**Comment Response Matrix for
NRC Staff Clarification Questions on
DOE Responses to
Request for Additional Information on the
Draft Basis for Section 3116 Determination and
Associated Performance Assessment for the
H-Area Tank Farm at the Savannah River Site**

January 2014

Prepared by: Savannah River Remediation LLC
Waste Disposal Authority
Aiken, SC 29808

Figure CQ-2.1: Comparison of Total Initial Curies of Cs-137 for All HTF Sources

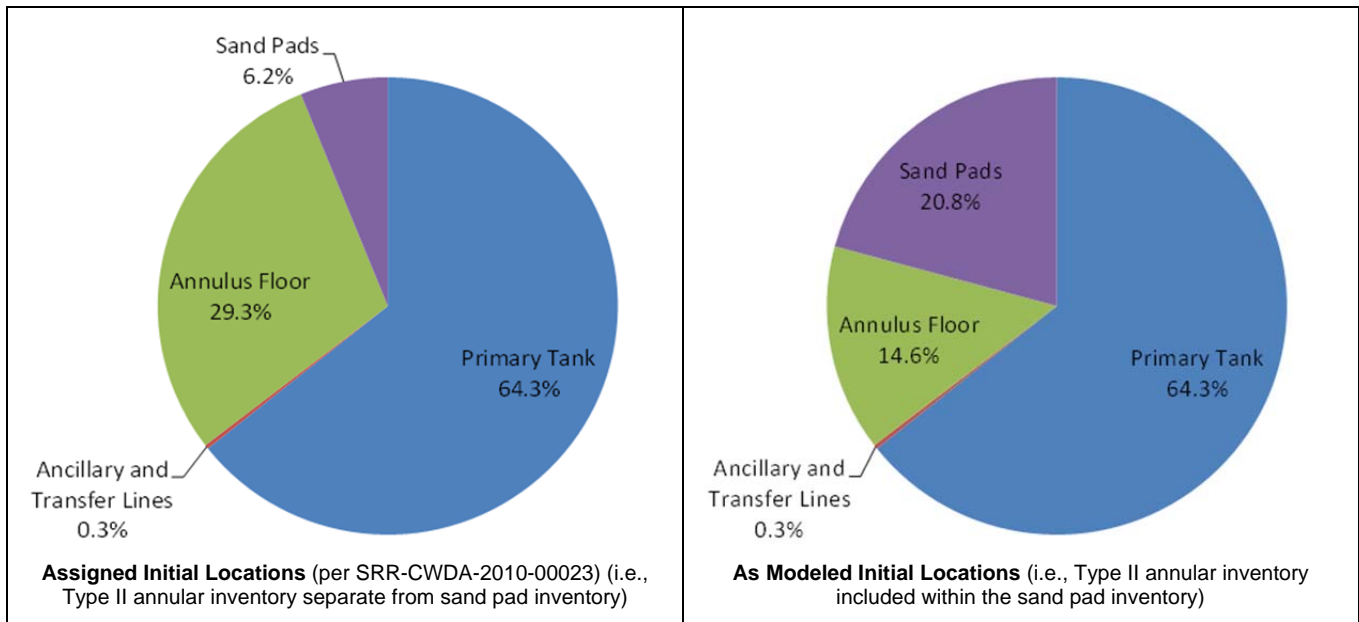
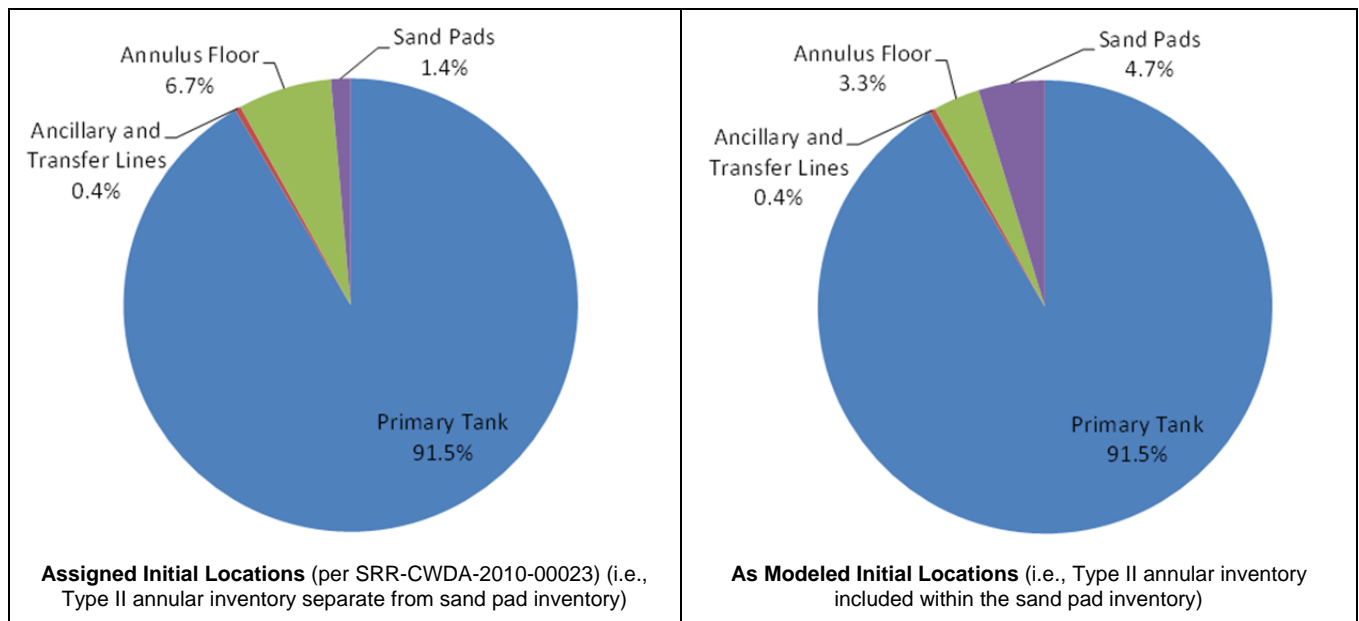
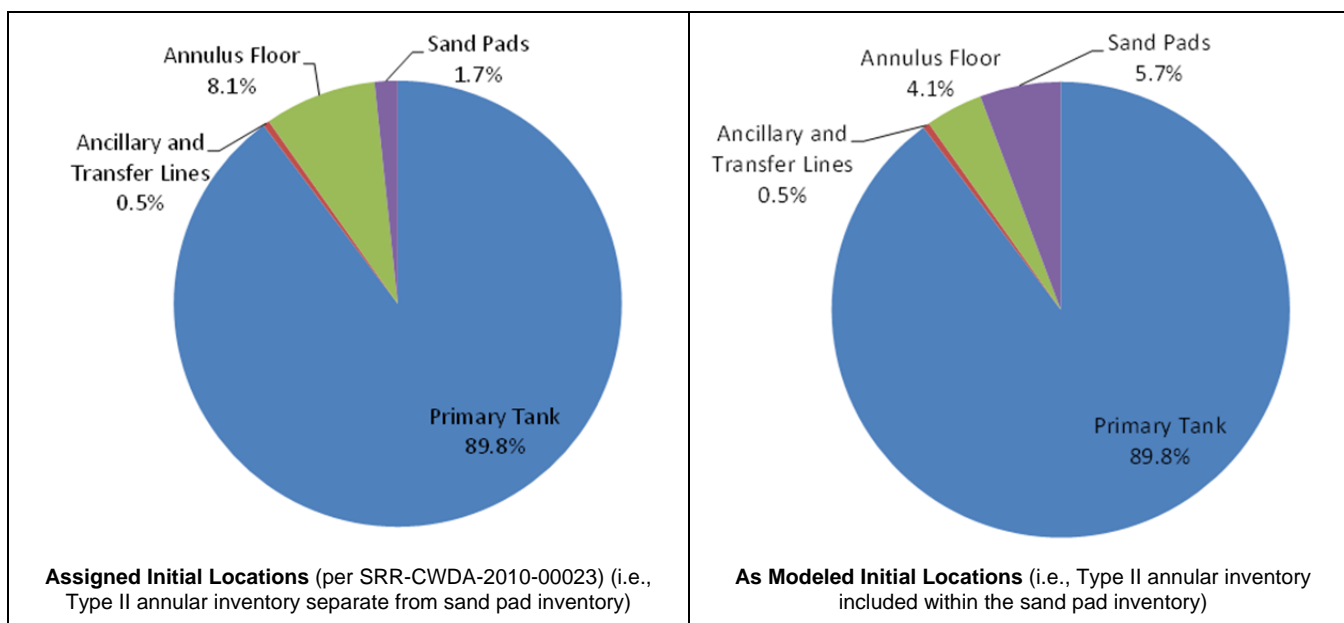
It is not clear to NRC staff whether DOE's response to RAI-NF-12, which relied on an analysis described in RAI-NF-8, adequately accounts for annular inventories. Please provide a table of the fractional release of Cs-137, Sr-90, Tc-99 out of the tanks and the mass storage in tank materials (e.g., sand pads, contaminated zone, basemat, annular grout, tank grout, tank wall concrete, preferential flow paths) over time for the analysis provided to respond to RAI-NF-12.

Figures CQ-2.1 through CQ-2.3 provide graphical representations of the initial inventory locations for Cs-137, Sr-90, and Tc-99, respectively, for the entire HTF inventory. These figures show the entire inventory for each material zone as summed over the entire tank farm. The figures provide a comparison of the "assigned" inventory¹ (i.e., with the sand pad and annular inventories separated in the Type II waste tanks) versus what was modeled for the HTF PA and for the RAI Response Document (i.e., annular inventories included within the primary sand pad zones for the Type II waste tanks). Note that the pie charts for the "as

Figure CQ-7.1: Low Zone Outside H Area Southwest of HTF (Wells with Residuals > 6 foot)

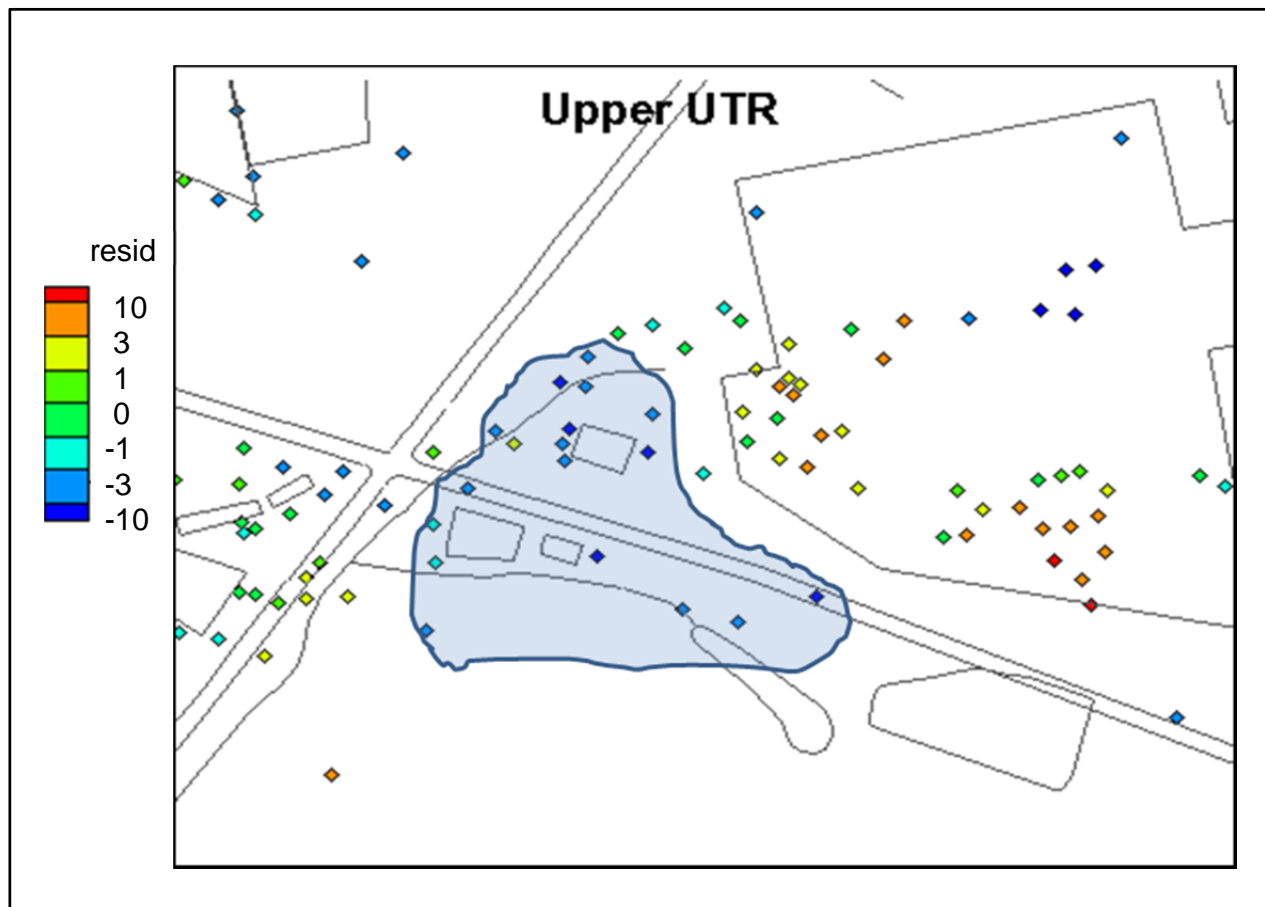
Please provide a legend for Figure RAI-FF-1.1.

The legend for Figure RAI-FF-1.1 from the RAI Response Document is the same as that used in Figure RAI-FF-1.2. Figure RAI-FF-1.1 is reproduced below with the addition of a legend for identification of well residuals values, measured in feet.

Figure CQ-9.1: UTRA-LZ Calibration Residuals (ft)

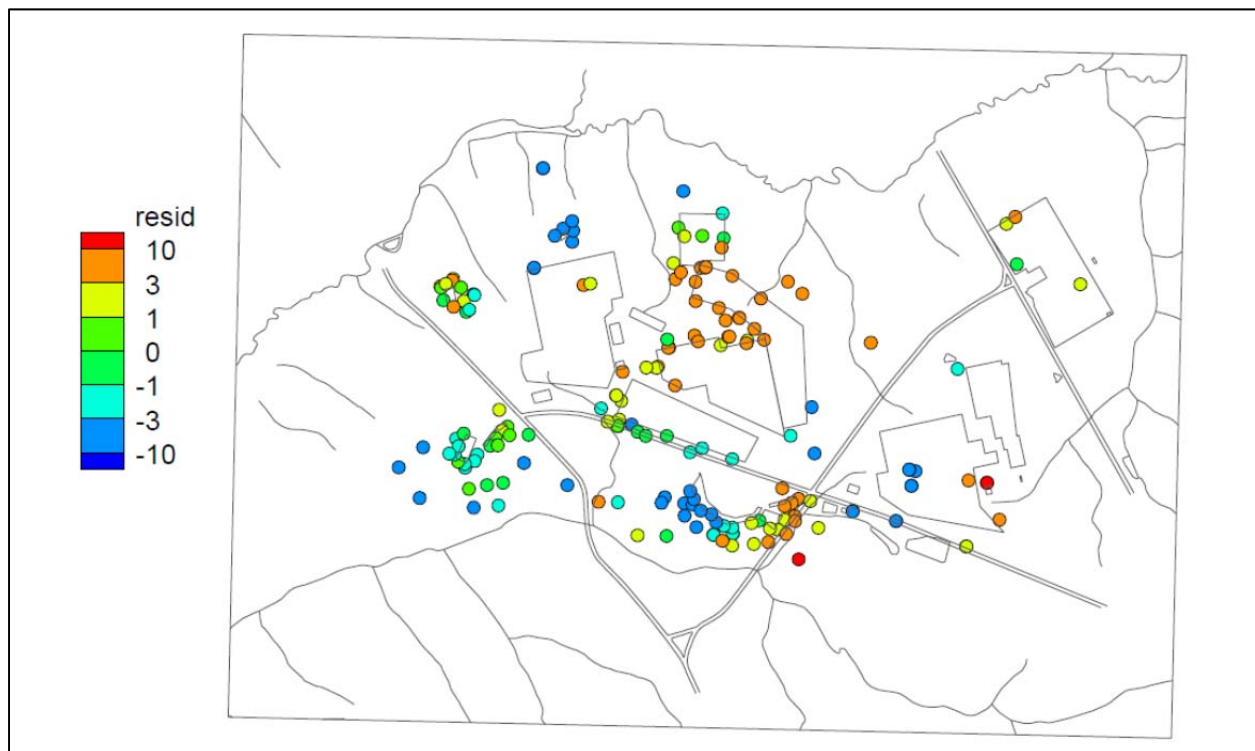
If no UTR-LZ calibration targets were evaluated in Table RAI-FF-2.4 for HTF, please comment on whether UTR-LZ calibration targets are available and on DOE's ability to evaluate HTF PORFLOW model calibration given the strong vertical gradient at HTF.

A few UTRA-LZ targets were available in the vicinity of HTF and were considered during calibration of the GSA/PORFLOW model. The calibration results for the UTRA-LZ targets are indicated in Figure 3-4(b) of *Groundwater Flow Model of the General Separations Area Using PORFLOW*, WSRC-TR-2004-00106, reproduced here as Figure CQ-9.1.

Figure CQ-11.1: 100-Meter Concentration Breakthrough Curves for 5-Year Pulse Release

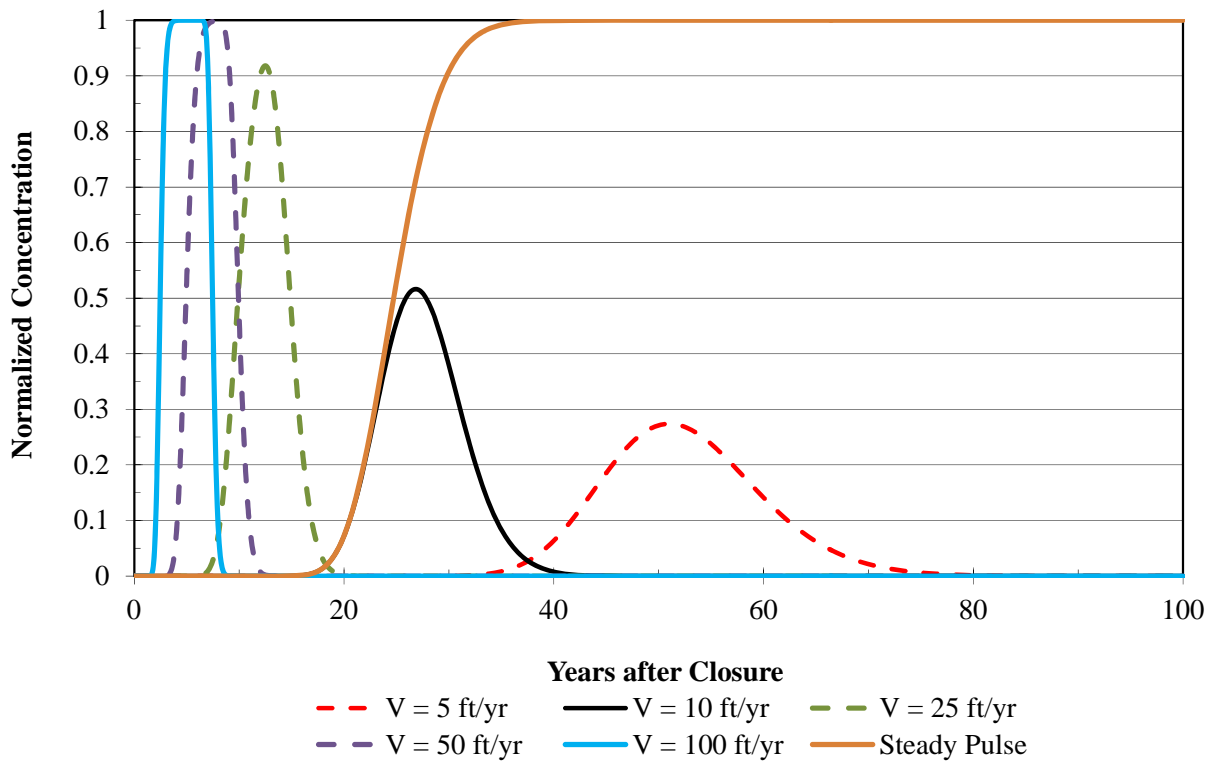
Please explain why Darcy velocity is not expected to impact longitudinal dispersion in the GoldSim model (see CC-FF-4 response on page 195).

The combined influence of the Darcy velocity and release profile will also influence the geometry of the plume. For a pulse release, the length of the pulse and velocity of the flow field together determine when and if the breakthrough curve reaches a quasi-steady state, and for how long the quasi-steady state condition will continue. For example, consider the results for the 5-year pulse simulation presented in Figure CC-FF-4.1 of the RAI Response Document. To show the combined influence of the flow rate and pulse duration, the 5-year pulse model was simulated using the updated velocities of 5 ft/yr, 25 ft/yr, 50 ft/yr, and 100 ft/yr. Note that the mass flux applied was also adjusted by factors of 0.5, 2.5, 5, and 10, respectively making the boundary concentrations, $C_o(t)$, the same so that dilution associated with the vadose zone/saturated zone water flux balance, was negated. The results are presented in Figure CQ-11.1. Notice how the changes in Darcy velocity influence the width and location of the breakthrough curve and how close to reaching a quasi-steady state condition each breakthrough curve comes. In the 100 ft/yr breakthrough curve a quasi-steady state condition is retained for approximately 3 years. As the velocity increases, the quasi-steady state condition will approach the pulse duration. These results can be anticipated by thinking of the pulse release in terms of superposition of two infinite source breakthrough curves as follows:
